Subject: Agenda for 49th Protection Sub-Committee Meeting.

Agenda for
49th Meeting of Protection Sub-Committee (PSC) of
Northern Regional Power Committee

A.11. SPS for 2X315 MVA, 400/220kV ICTs at Suratgarh Thermal Power Station (Agenda by RVPN)

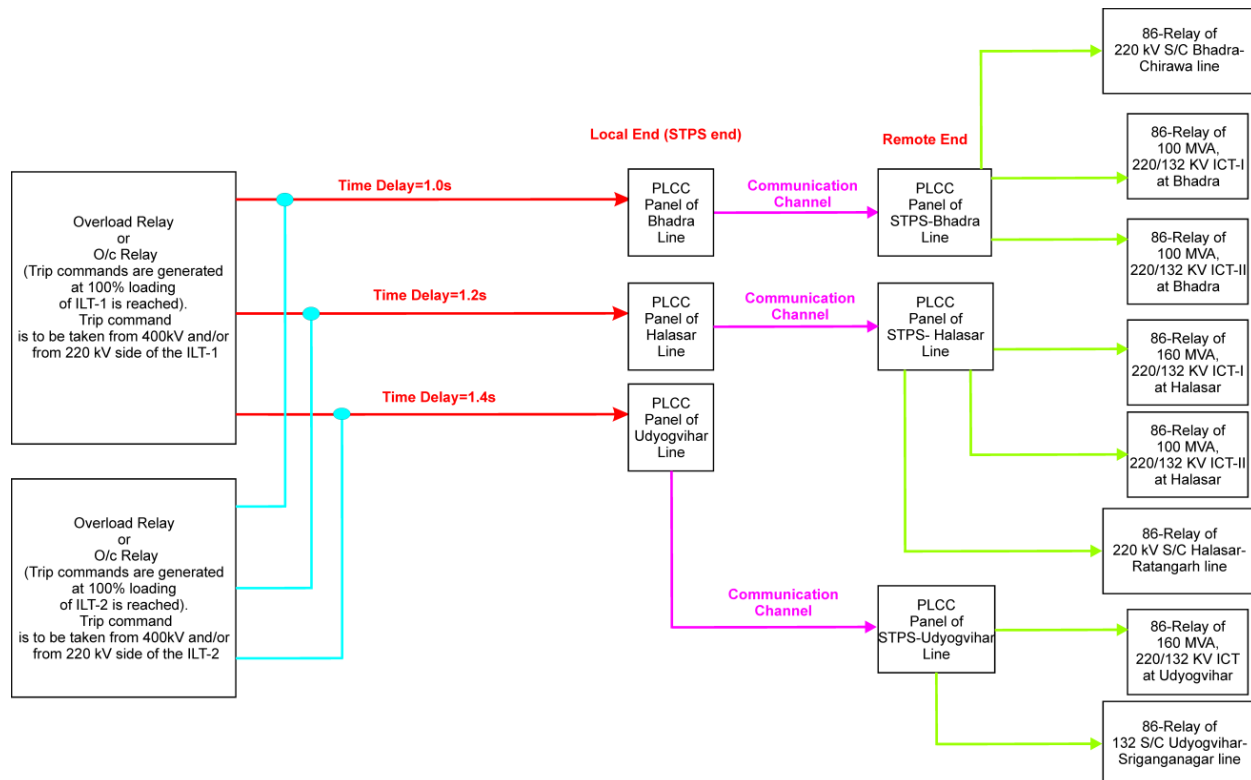
As per the revised SPS logic submitted by RVPN:

Following are comments from NRLDC side:

- The SPS seems to provide relief of 50-100MW as seen in simulation studies, therefore if ICTs are loaded beyond 400MW (on both ICTs), the SPS relief may not be able to provide the required relief.
- RVPN may confirm that there is no possibility of tripping any other feeders nearby for SPS operation i.e. 220kV Suratgarh-Suratgarh D/C and 220kV Suratgarh-

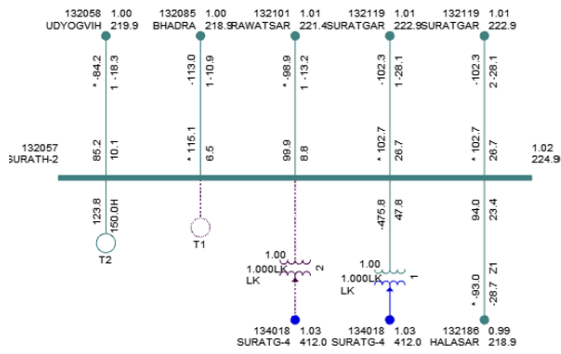
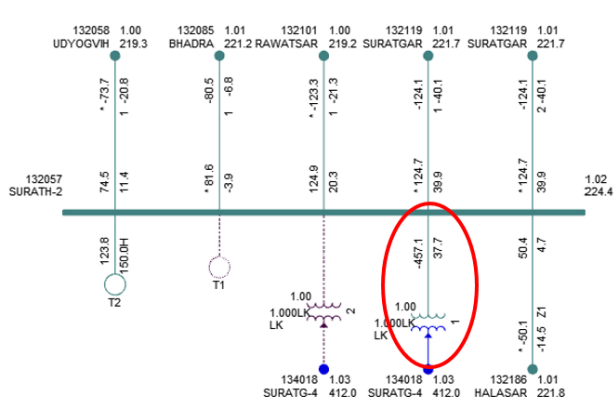
- Tripping of 220/132kV Bhadra may not help, as power will continue to flow to Chirawa.
- Further, on carrying out simulation studies for the logic proposed, it is seen that the SPS operation is not able to provide the relief to save one ICT as shown below:

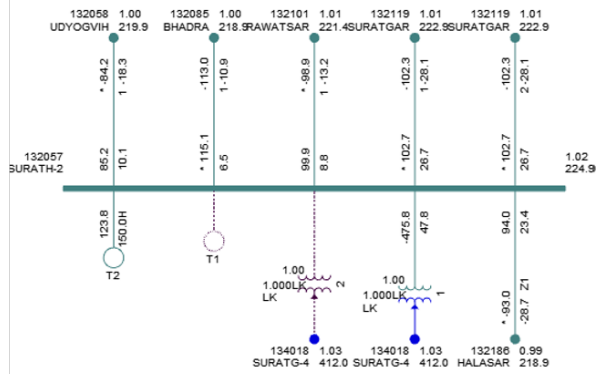
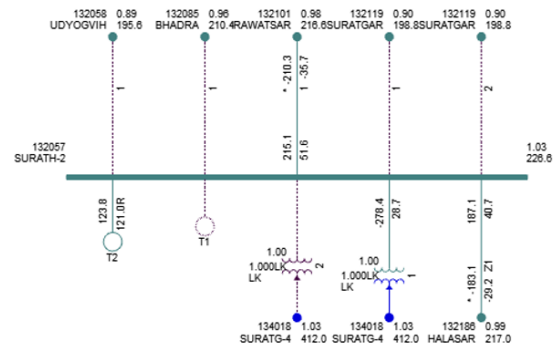
Further, another option was studied by NRLDC which may help to provide the required relief as shown below:

In this case, 4 no.s 220kV lines have been opened, namely.

- 220kV Suratgarh-Bhadra
- 220kV Suratgarh-UdyogVihar
- 220kV Suratgarh-Suratgarh D/C

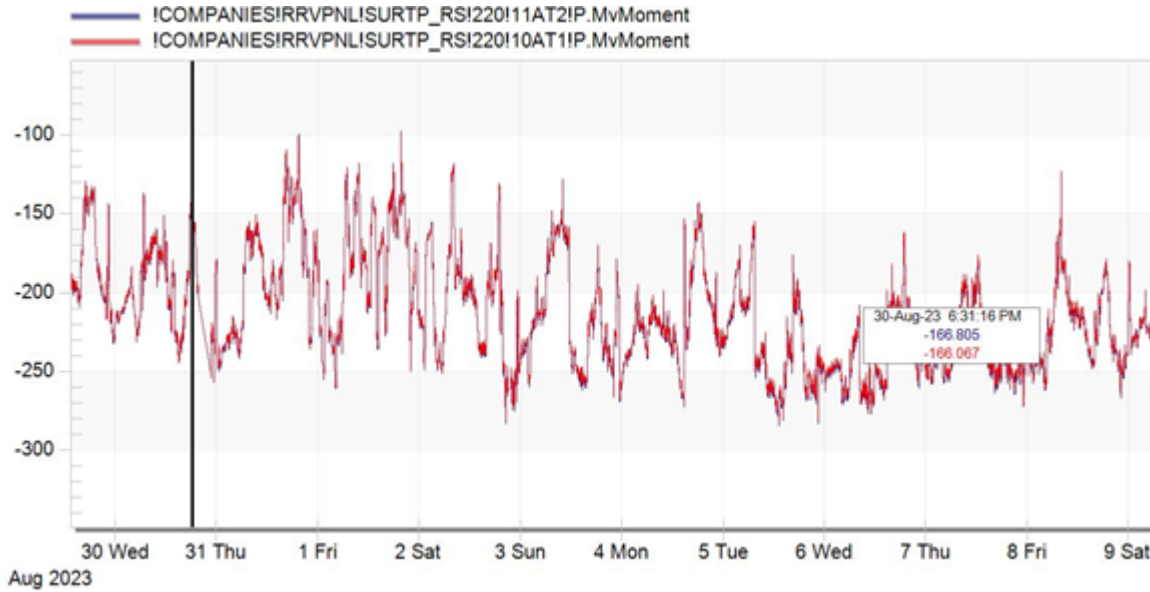
Loading of 2*315MVA 400/220kV ICTs at STPS & 220kV STPS-Bhadra/220kV STPS-Rawatsar/220kV STPS-Udyog Vihar/ 220kV STPS-Suratgarh lines for last 2-3 months (high demand period) is shown below:

Loading of 400/220kV ICTs remains in range of 200-250MW each during peak solar generation as shown below:

Considering above, it seems that tripping of 220kV STPS-Bhadra (loaded in range of 50-80MW) may not be able to provide the required relief.
